SERVICE DIRECTIVE BULLETIN

SERVICE NOTE NO. 0012

Subject: Tail Rotor Output Shaft Seal Housing

Model: F-28A - Serial Numbers 81, 82, 83, 84, 85, 86, 14, 62, 77 & 74

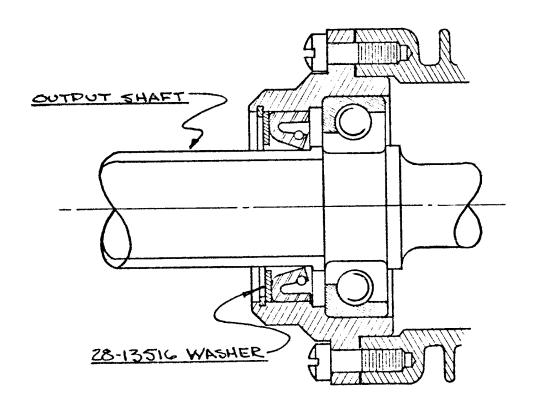
On the serialed helicopters listed above or any other units with the tail rotor output shaft seal that is externally mounted, the addition of a steel washer between the seal and the Truarc retainer is recommended. This will insure added integrity to the output shaft assembly in the event of an output bearing failure. See illustration.

To install the 28-13516 washer, remove the tail rotor assembly and pitch link retainer assembly. Remove Truarc seal retainer, install washer 28-13516by pressing output shaft seal inward .050 of an inch. Reinstall Truarc and reassemble.
